SERVICE BULLETIN 33

SUBJECT: GLASAIR III ENGINE MOUNT AND FIREWALL TEMPLATE.

APPLICATION: Glasair III kits; S/N 3015 thru 3026

FIGURE (1)

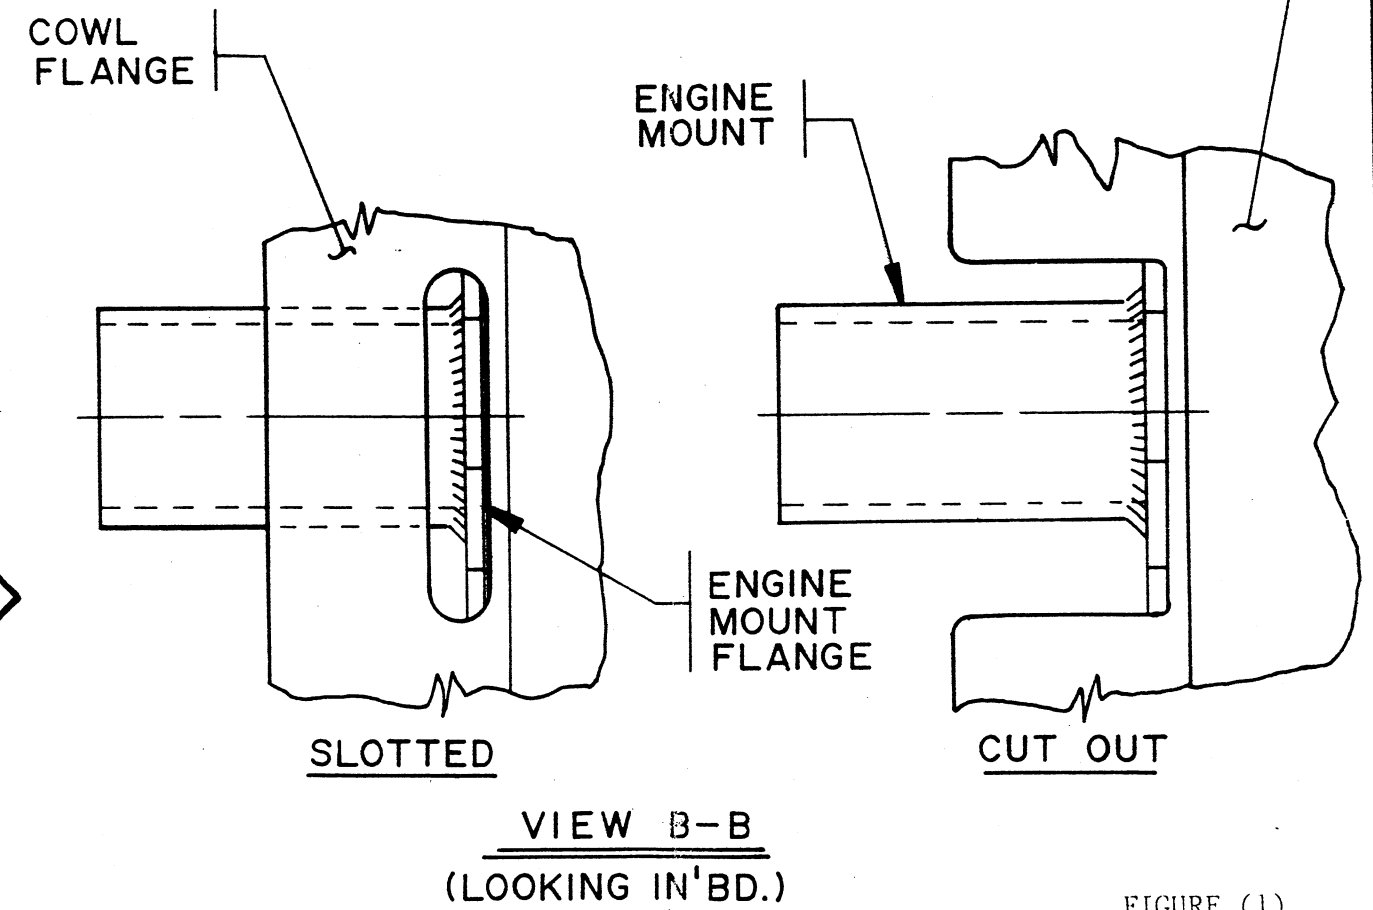
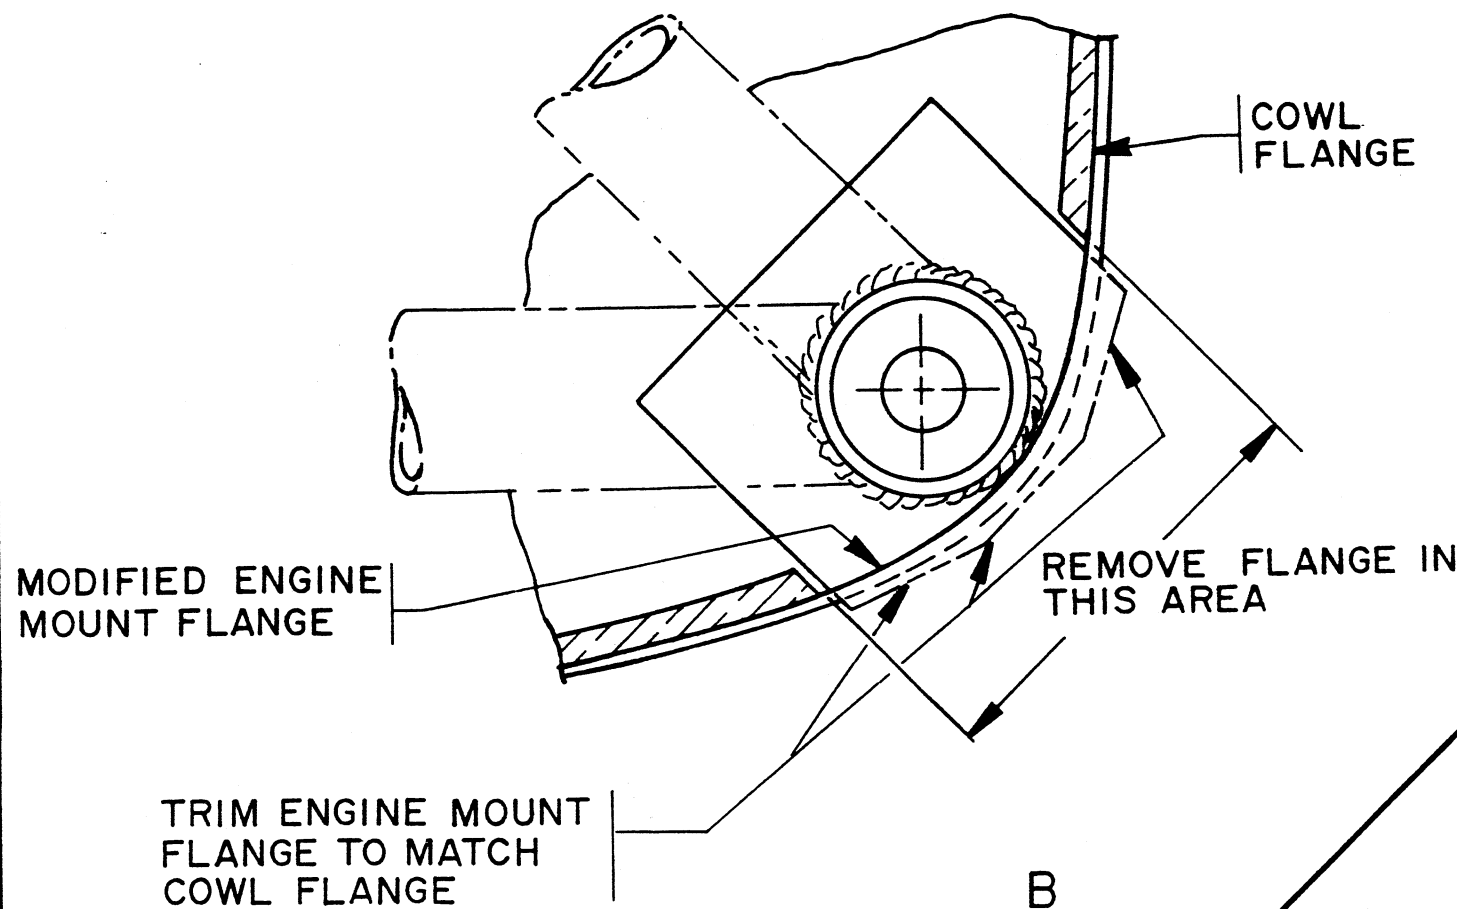
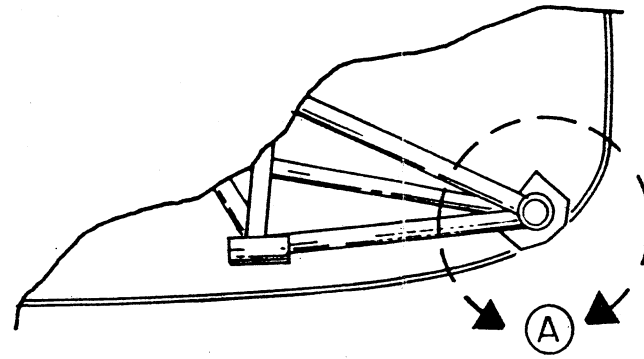
On the Revision A style engine mounts, the lower outboard engine mount points will require grinding of the base plates. The fiberglass cowl flanges must be locally trimmed back flush with the firewall or slotted to provide clearance for the baseplate. See FIGURE (1).

In addition a slight interference may exist between the lower corner engine mount tube and the lower cowling. The lower cowling slopes upward from the firewall and the engine mount tube extends straight forward. These tubes may also be ground for proper clearance when the lower cowling is fit to the aircraft.

NOTE: Grinding the base plates and trimming or slotting the fiberglass flanges are both structurally permissible and will not have any cosmetic effect pm the finished product.
